RENESAS TECHNICAL UPDATE

Product Category	MPU/MCU		Document No.	TN-RZ*-A021A/E	Rev.	1.00
Title	Ethernet MAC reception issue in case TCPIP accelerator enabled		Information Category	Technical Notification		
Applicable Product	RZ/T1 GROUP	Lot No.	Reference Document	RZ/T1 Group User's Manual: Hardware Rev1.2 R01UH0483EJ0120		
		All lots

Fig1: Flowchart of RX FIFO overflow processing task (In case of using HW-RTOS)

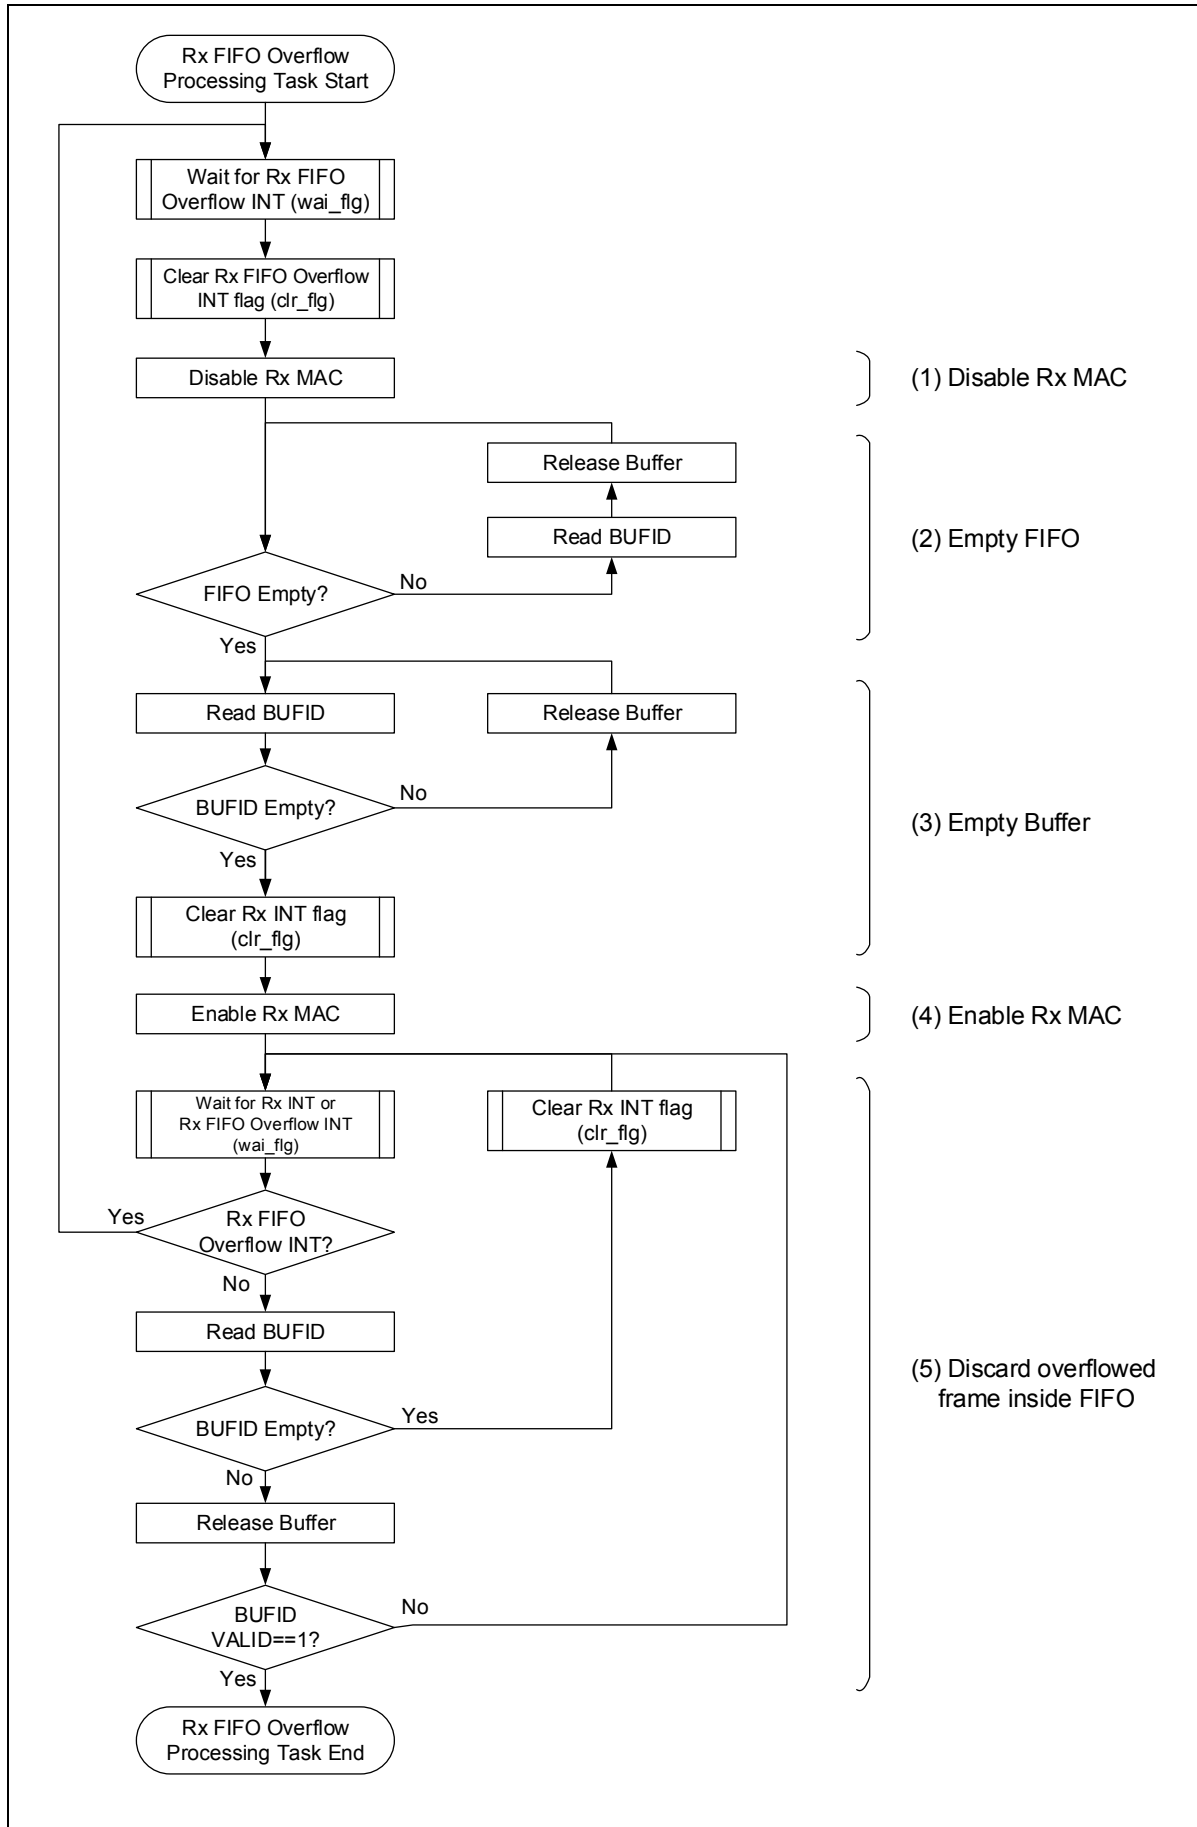
(B) When Rx FIFO is overflowed, discard all frames left in Rx FIFO and Buffer RAM. Specifically, apply the following procedure;

(1) Disable Rx MAC.

(2) Discard all frames left in Rx FIFO.

(3) Discard all frames left in Buffer RAM.

(4) Enable Rx MAC.

(5) Discard at least one frame with BUFID VALID bit = 1. This is because FIFO empty state can be read even if the frame which caused FIFO overflow remains in the FIFO. Receive normal frame once and discard remained abnormal frame with it.

- ✓ Create overflow processing task with higher priority than one of reception processing task
- ✓ Start overflow task by HWISR combined with FIFO overflow interrupt
- ✓ Discard the abnormal frame remained in the FIFO by HWISR combined with reception interrupt

Fig 5: Flowchart of Reception processing

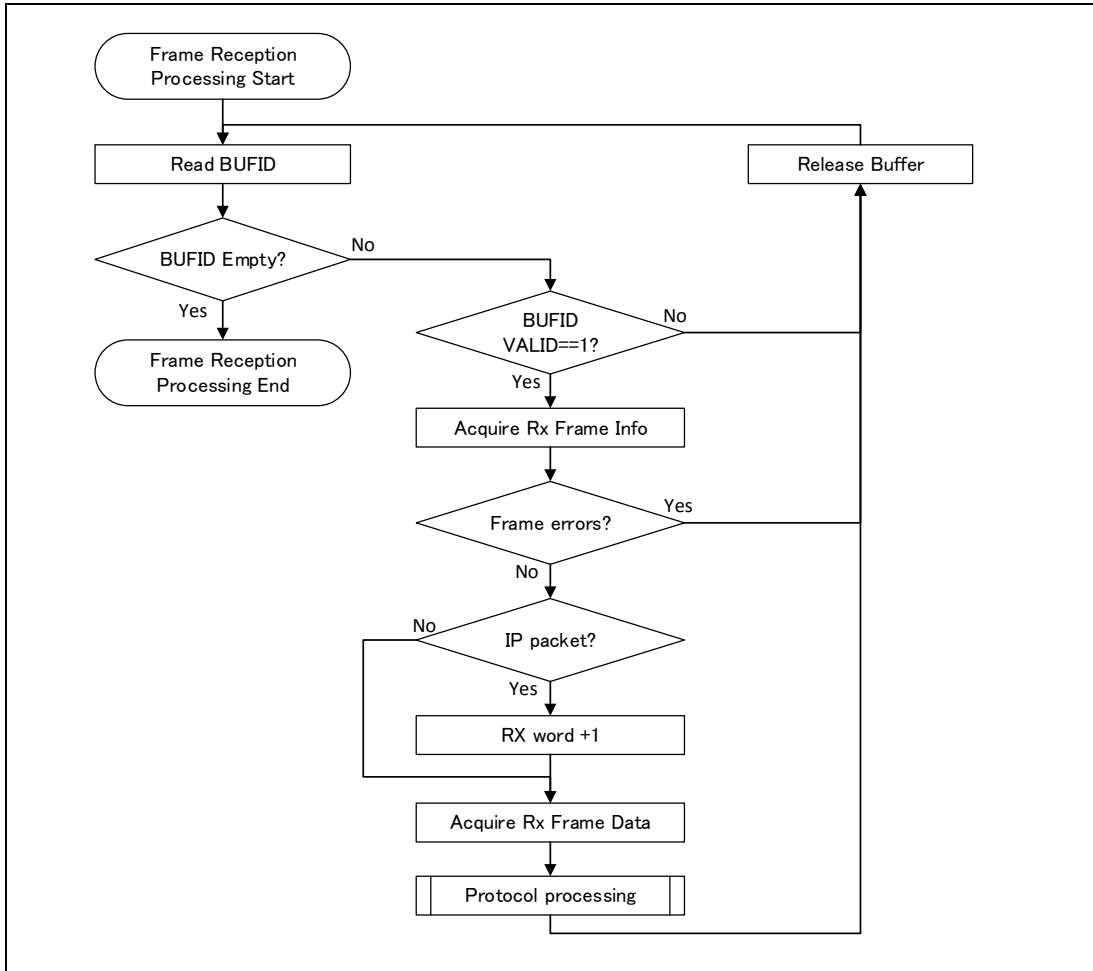
It is possible that reception word size (RX_WORD[12:0]) in the frame information increases by 1 word (4 bytes) or decreases by 1 word compared with correct size. In case of decrease by 1 word, it is possible that RX_WORD indicates the size which causes lack of IP packet. IP packet itself is NOT lacked.

- (B) In order to avoid lack of the IP packet, increase reception word size by 1 and transfer the size to protocol stack.

In the protocol stack, payload data should be extracted based on size of Total Length field in IP header and the rest data should be discarded. Fig 5 is the flowchart of this workaround.
